**RE: SUPPLEMENTARY FLOOD ASSESSMENT IN RESPONSE TO SHOALHAVEN CITY COUNCIL REQUEST FOR FURTHER INFORMATION – PROPOSED EXPANSION OF SAND EXTRACTION AT PIG ISLAND, TERARA, NSW**

Martens and Associates (**MA**) have prepared this response on behalf of Terara Shoalhaven Sand (the **Proponent**) to address the flood related items in the Request for Further Information (**RFI**) from Shoalhaven City Council (**Council**, dated 19 April 2022, REF: RA21/1000) in relation to a proposed expansion of sand extraction at Pig Island, Terara, NSW (the **Site**).

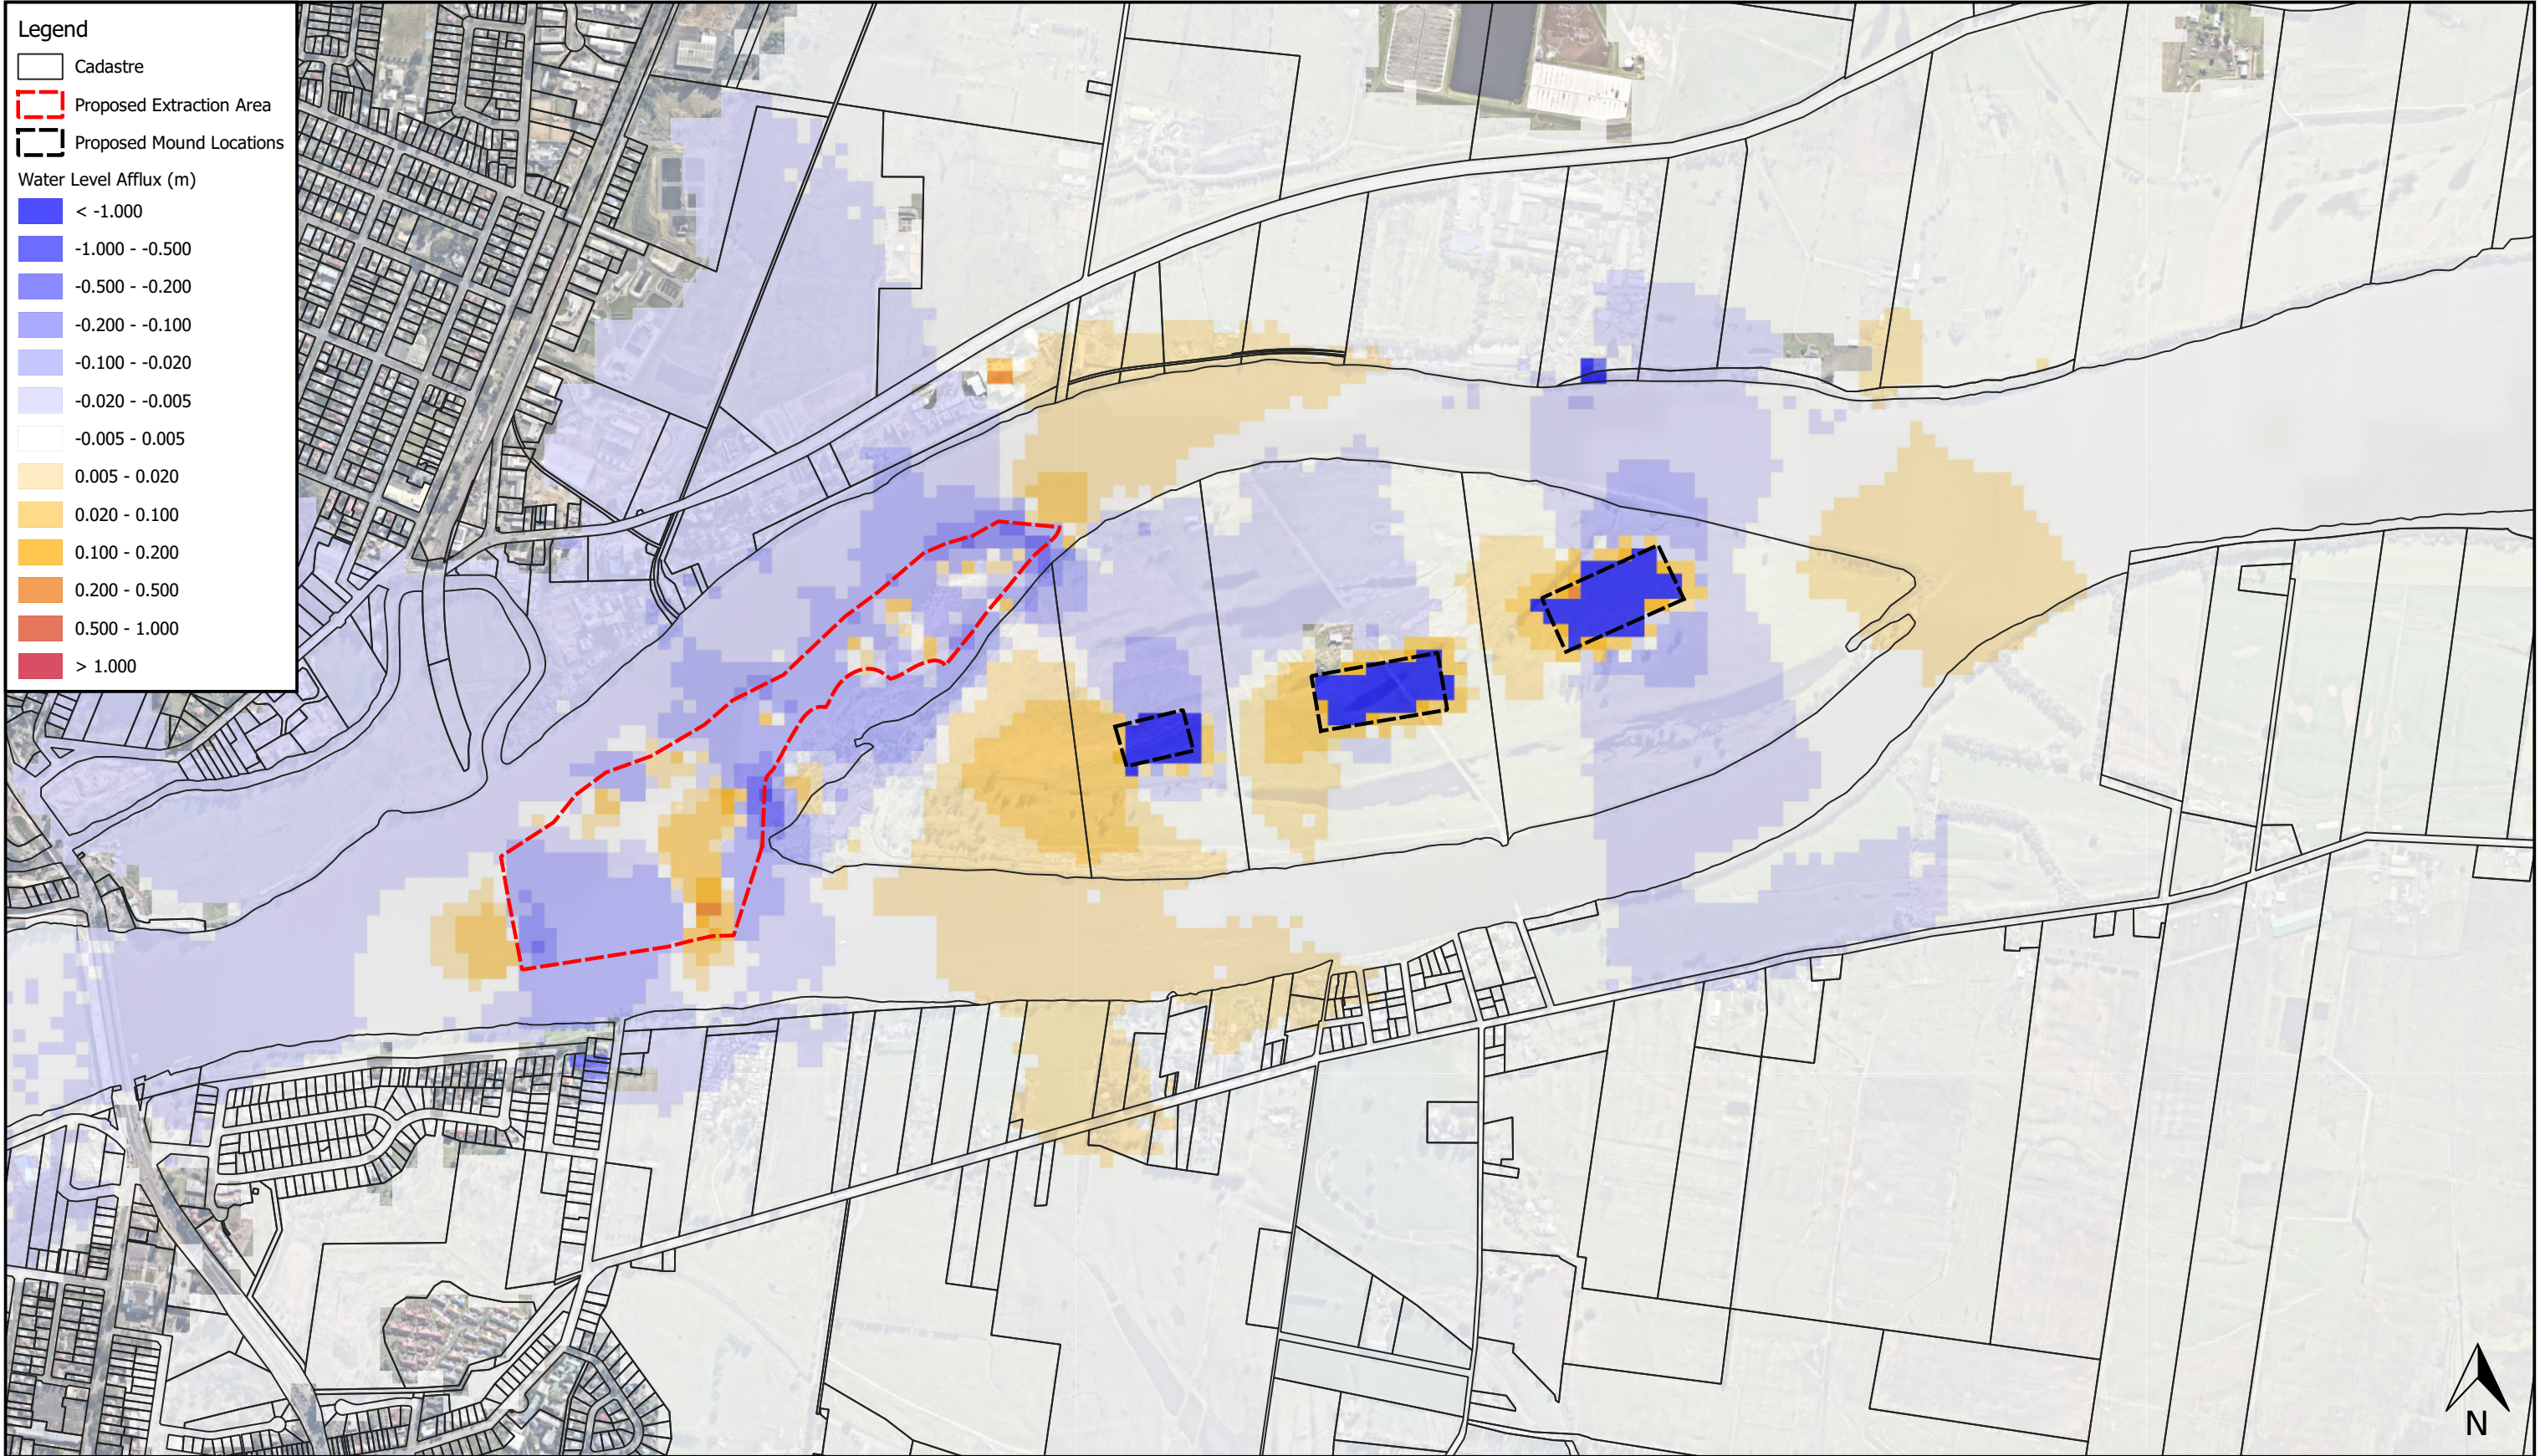
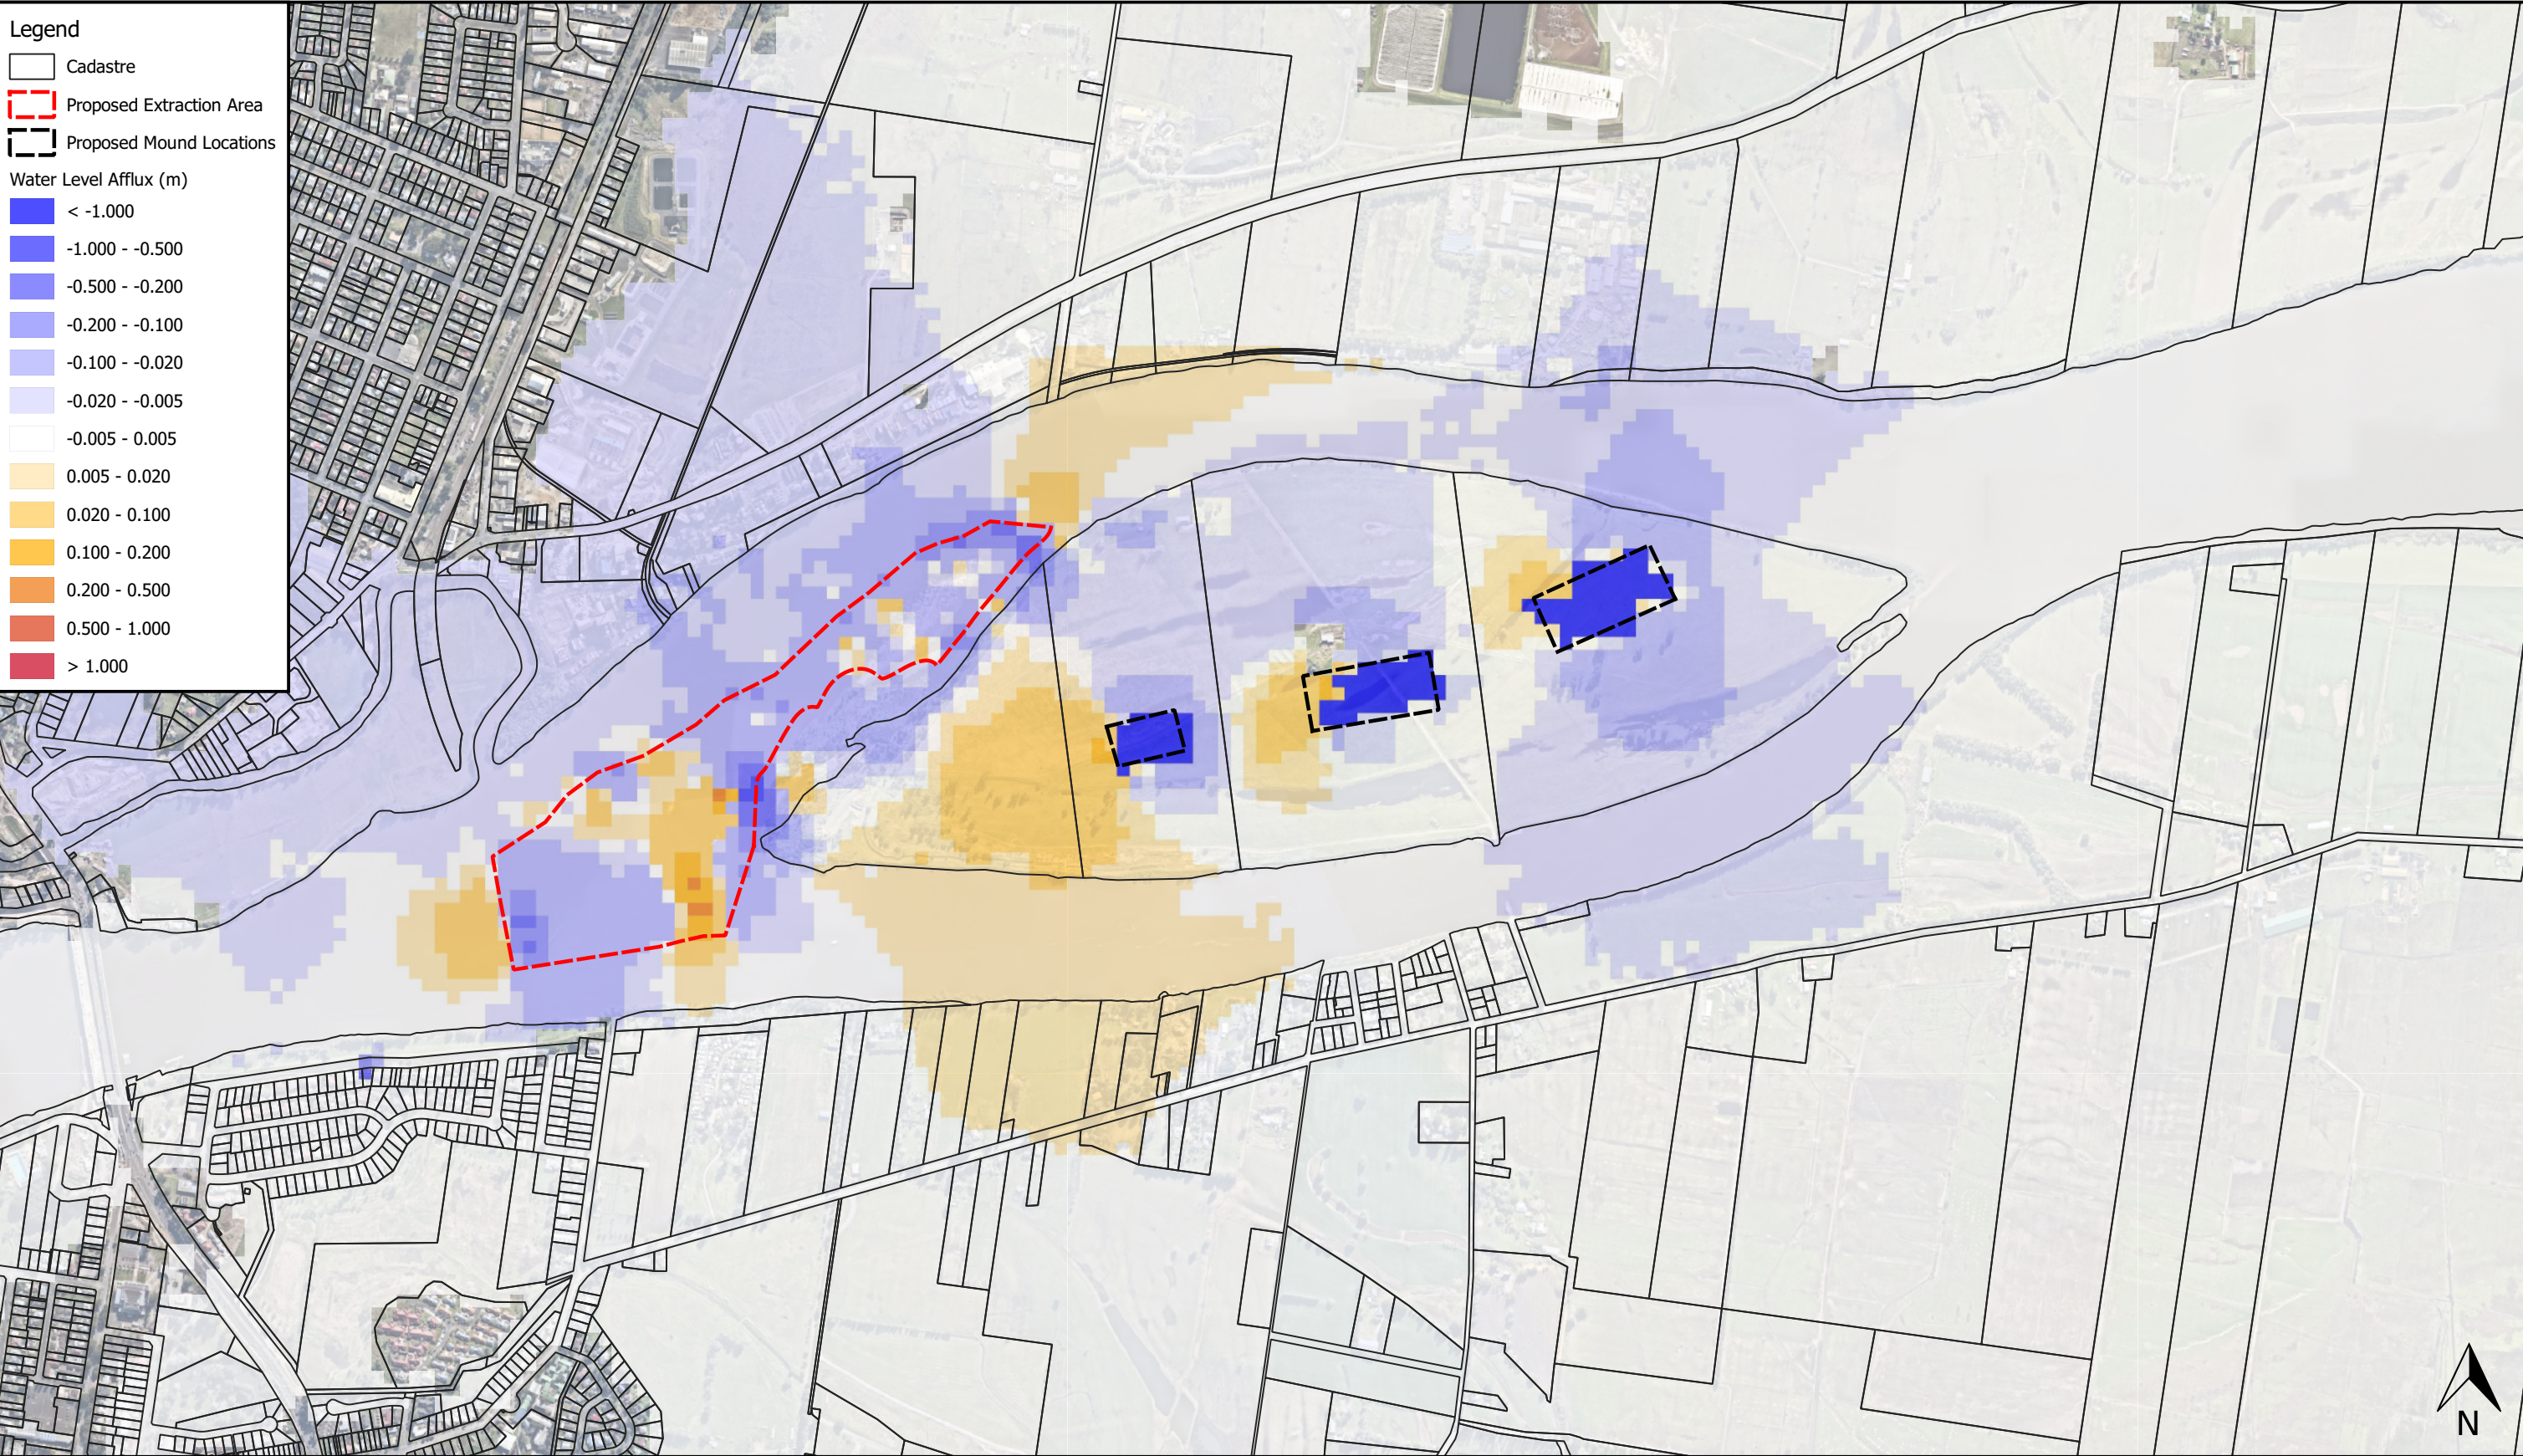
<p>h) <i>The report identifies that the expanded dredge area would result in negligible changes to flood velocities, hazard and hydraulic categories. It is however noted that no velocity difference maps have been provided. Velocity difference maps are required for the full range of flood events modelled.</i></p>	<p>(8) See Attachment A Map FL02, Map FL04, Map FL06, Map FL08 &amp; Map FL10 for the full range of velocity afflux maps.</p>
